SUBJECT: Final Remedial Design Report for the Ash Landfill Operable Unit at Seneca Army Depot Activity; Contract FA8903-04-D-8675, Delivery Order 0012, CDRL A001G and A013

**FINAL
REMEDIAL DESIGN REPORT
FOR THE ASH LANDFILL OPERABLE UNIT
SENECA ARMY DEPOT ACTIVITY**

- Appendix A Design Drawings
- Appendix B Technical Specifications
- Appendix C Technical Memorandum: Final Evaluation Report for the Mulch Biowalls at the Ash Landfill Operable Unit
- Appendix D Response to Comments

PARSONS	
SENECA ARMY DEPOT ASH LANDFILL REMEDIAL DESIGN	
ENVIRONMENTAL ENGINEERING	DWG NO 744538-01400
FIGURE 7-3 LONG-TERM GROUNDWATER MONITORING DECISION DIAGRAM	
SHEET 1 OF 2	JUNE 2006

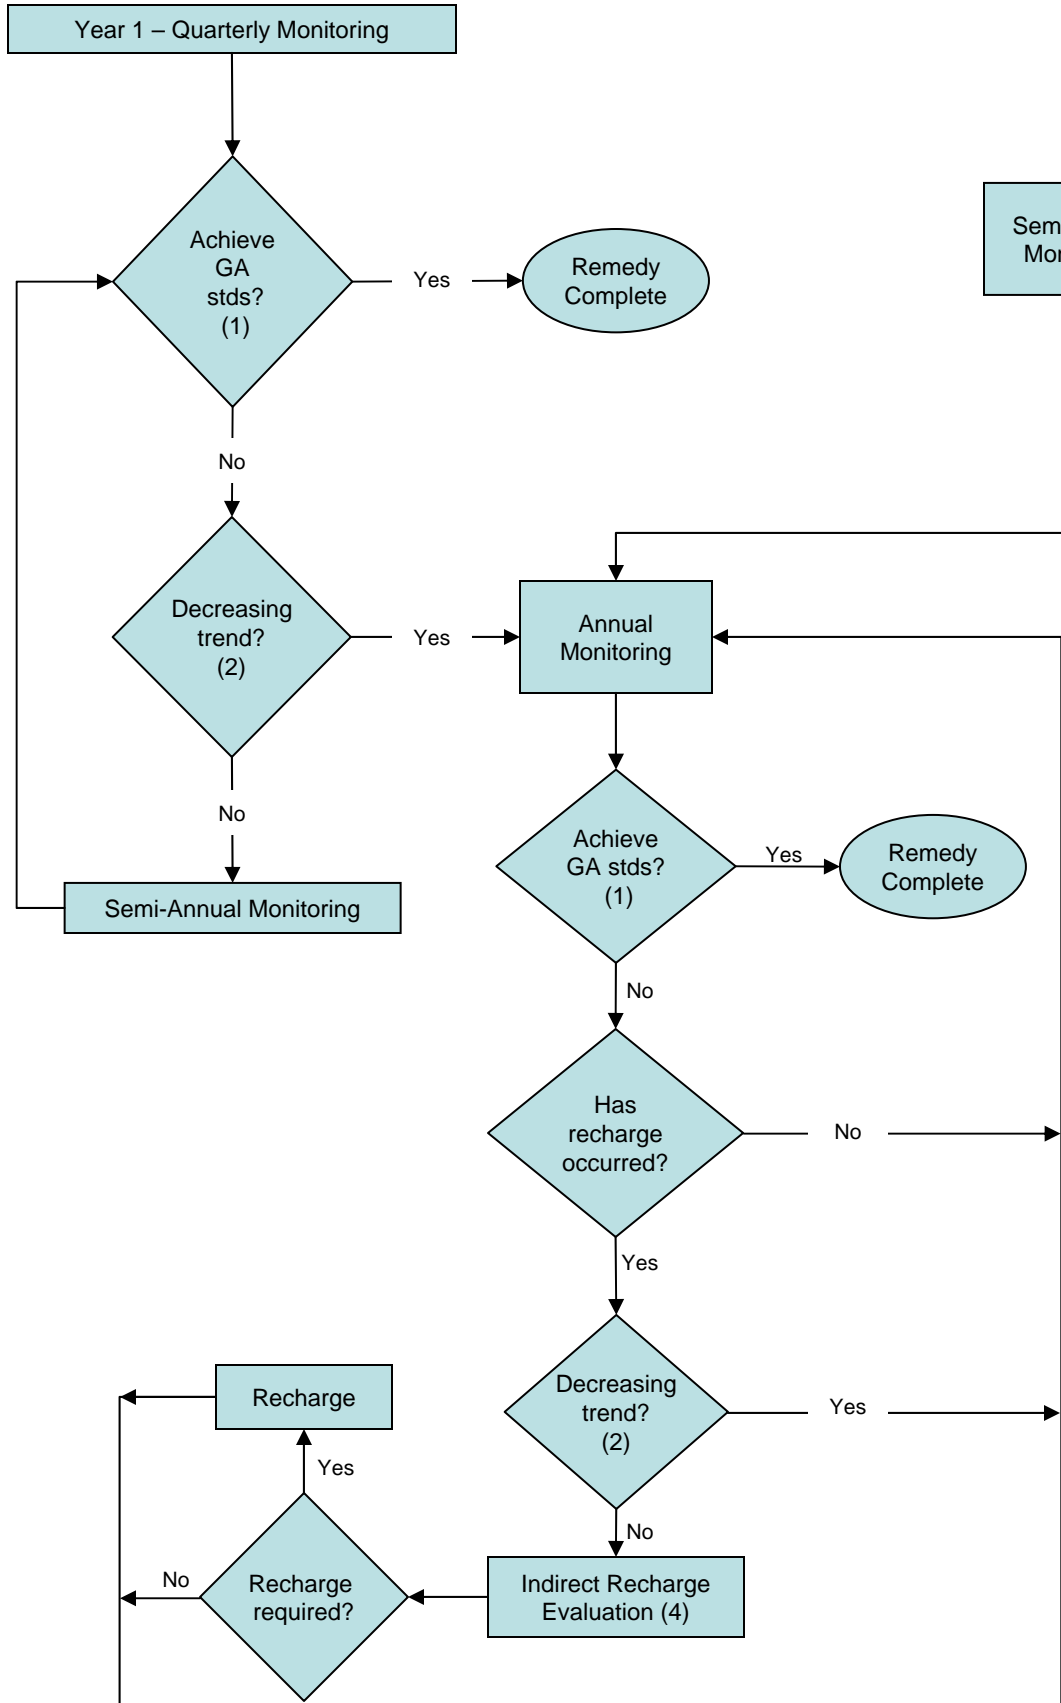
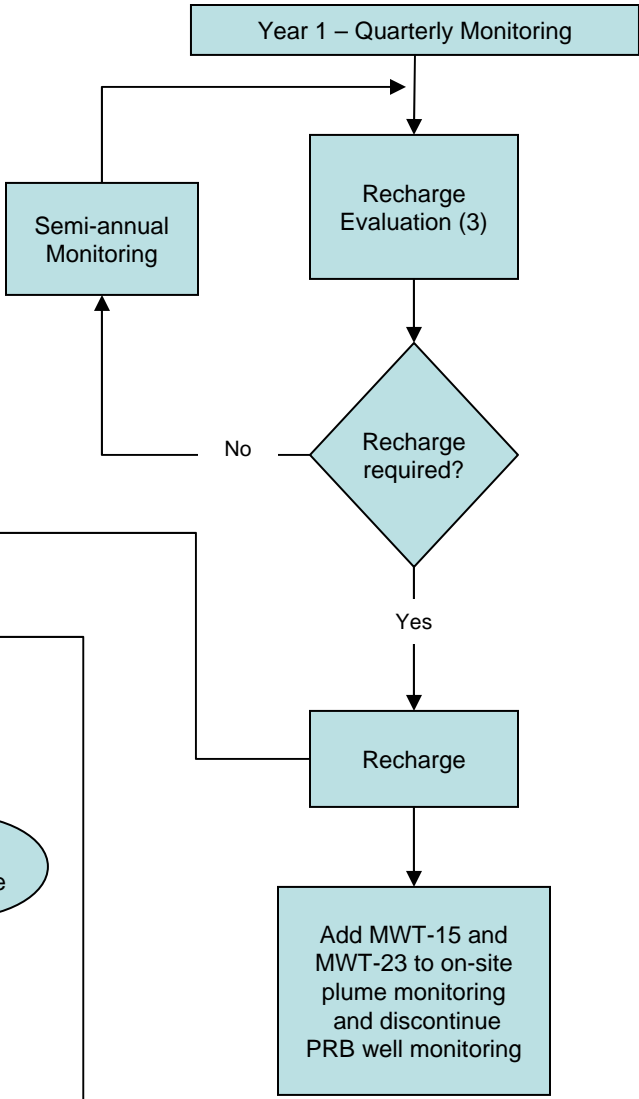
Figure 7-3, Notes, Item 1- Achieving GA Stds on site:

Response 1: The purpose of the long-term monitoring plan and, specifically, of the decision diagram outlined in Figure 7-3, is to establish a defined process for evaluating the groundwater monitoring program and for detailing the frequency and duration of monitoring. It is the Army’s desire that the long-term monitoring plan be definitive as to when monitoring requirements would terminate. The ROD states that monitoring will be conducted at the site until NYSDEC GA standards are achieved. The Army’s original wording provides a clear blueprint for when the GA standards in the on-site wells have been achieved. Currently, the Army has recommended that after two successive monitoring events, if GA standards are achieved in all on-site plume wells, the remedy would be complete and no further monitoring would be required for the Ash Landfill Operable Unit. Under the Army’s proposed plan, since monitoring would cease after two successive rounds of acceptable data as currently defined, there would not be a “subsequent” round. Therefore, the text in the note on Figure 7-3 remains unchanged.

Response 2: Graphs and statistics will be used, as appropriate, to determine the trend of the analytical data. The text in Figure 7-3 and on Page 7-5 has been modified.

**C-4
 GROUNDWATER REMEDIATION:
 BIOWALLS LAYOUT**

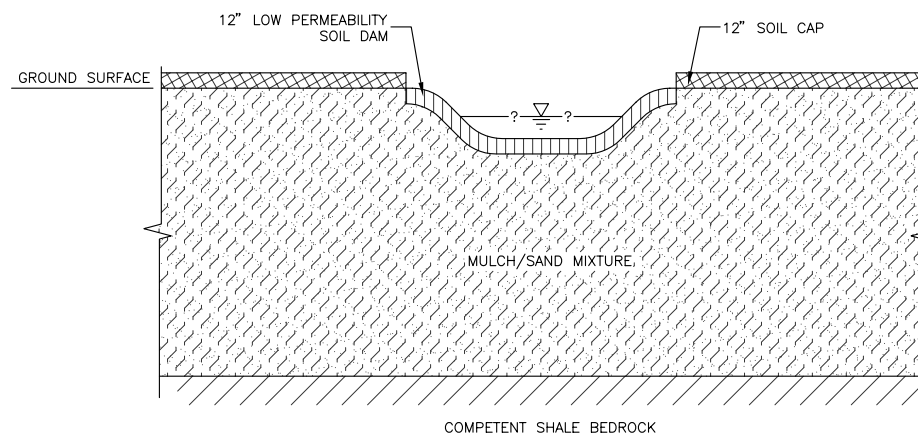
Comment 4, Page 4-9, Second paragraph: After "Drawing C-4", the text indicates the space between walls as 15 ft. However, the drawings show a space of only 12 feet. Please correct.

Response 1: Biowalls B1, B2, C1 and C2 will be extended 50 feet to the north as suggested. Table 3-1, Figure 7-2, Figure 10-1, Drawing C-4, Specifications 01010, Specification 02221 and text related to wall lengths and excavation volumes has been updated to reflect this. Regarding the technical memorandum documenting the assumptions of the design, such a report was written and included with the Remedial Design Work Plan for this site. This memorandum will be included as Appendix C of the Remedial Design Report and is now referenced in Section 3, Basis of Groundwater Remediation Design.

Response 4: The text in question has been modified to read: "The walls within each pair will be spaced approximately 15 feet apart measured from the centerline of each trench." Since each trench is three feet wide, this would translate into a 12-foot separation between the edges of each trench, as indicated in Drawing C-5.
